May 31, 2012

Re: WPX and Oxy Transferring Operator COA Response (Doc #2224707)

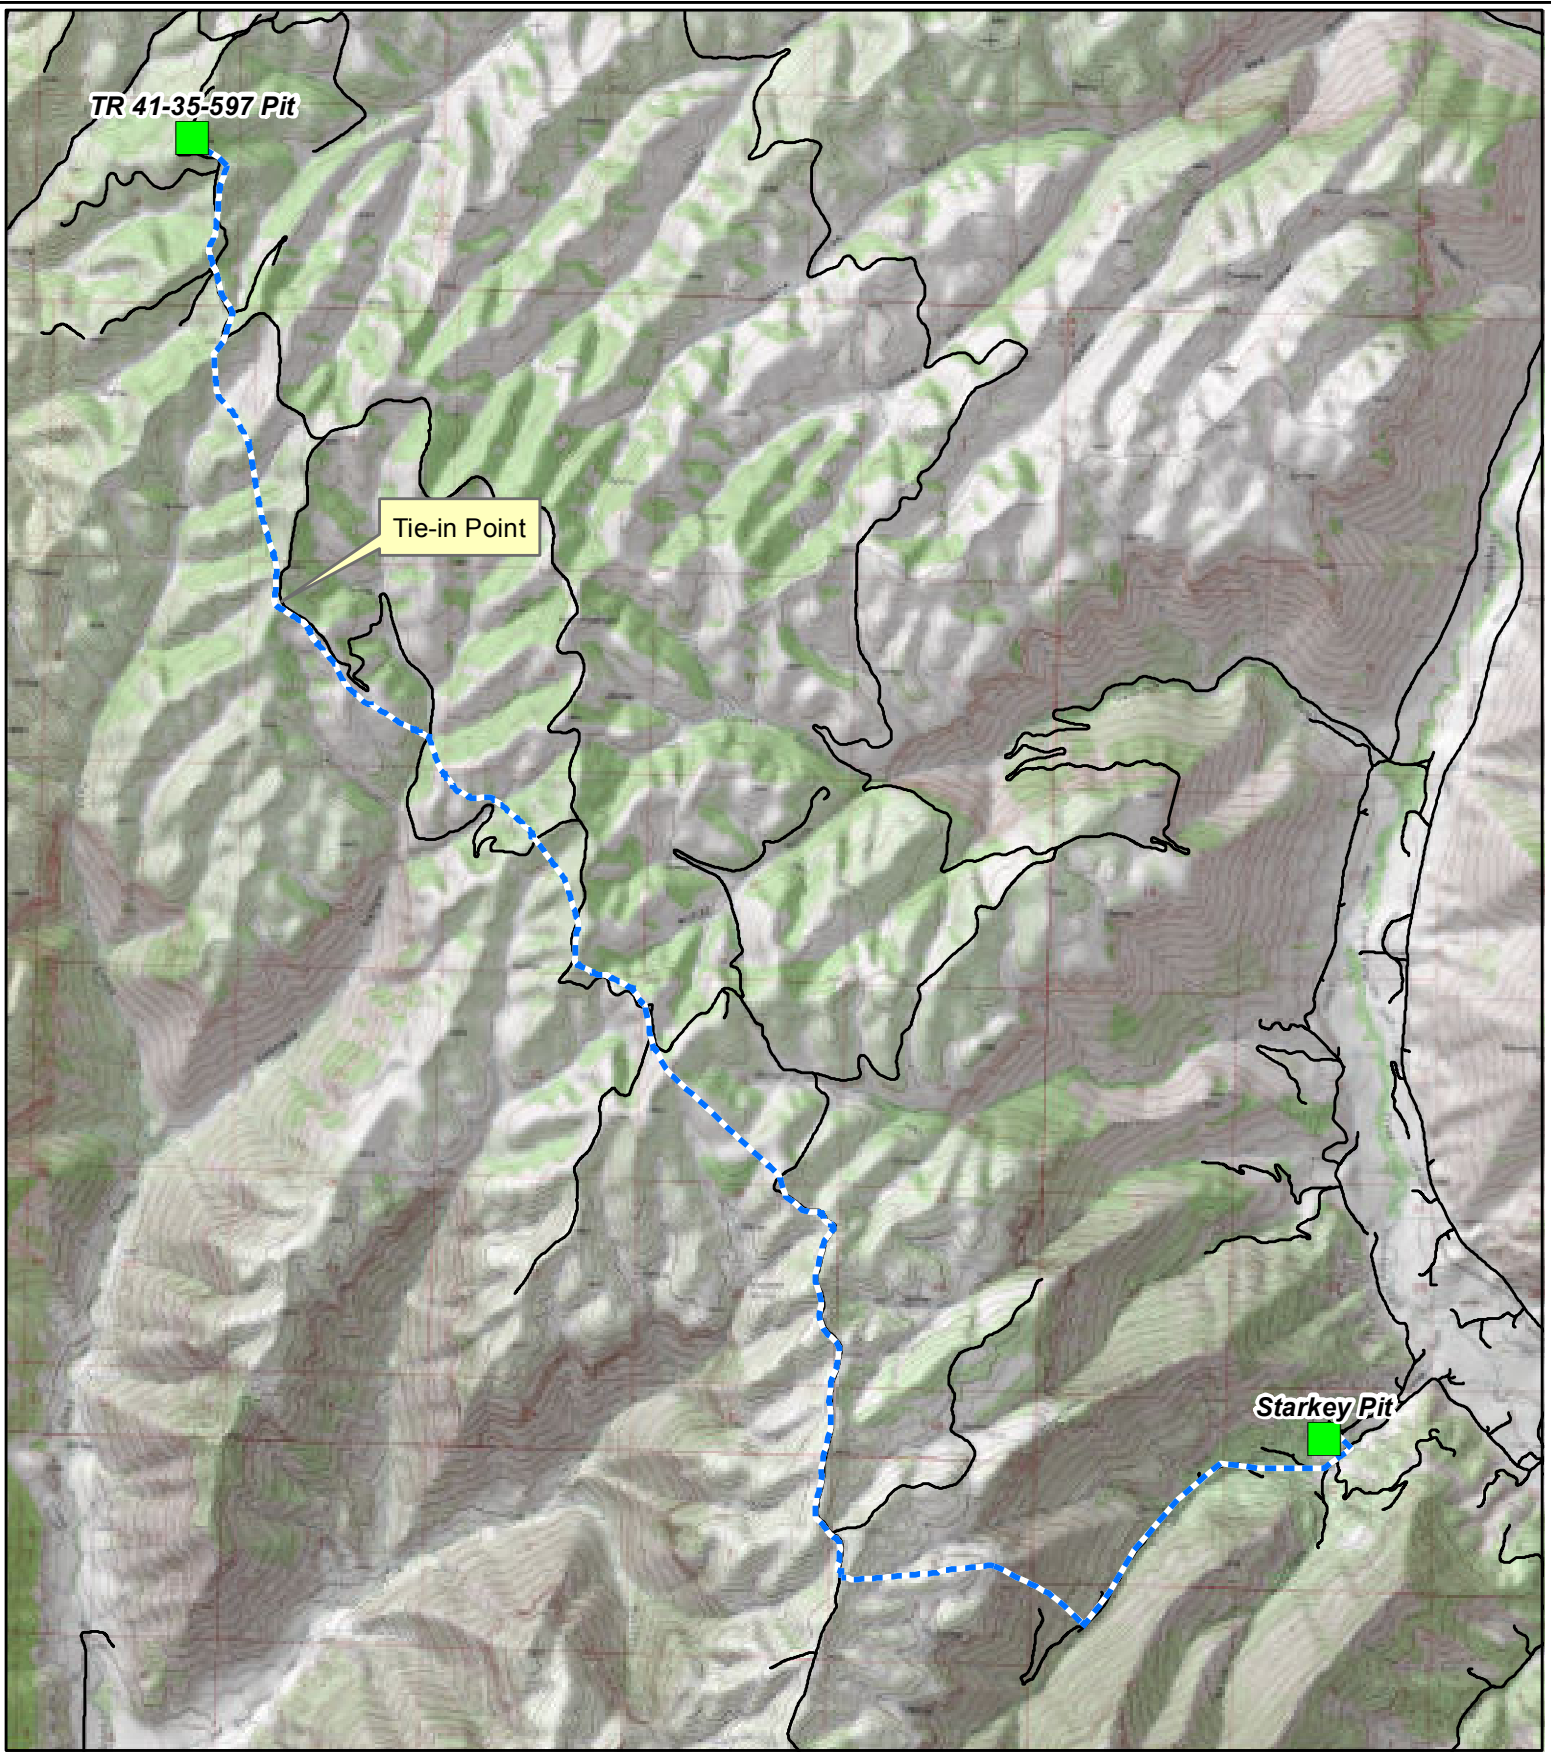
COA- PROVIDE MAPS OF THE PIPELINE DISTRIBUTION SYSTEM(S) FROM WPX Location IDs 422272 and 422267 AND TO LOCATIONS 335643 AND 423240 BY JUNE 1, 2012.

See attached map showing the WPX pit locations, water line routes and custody transfer point
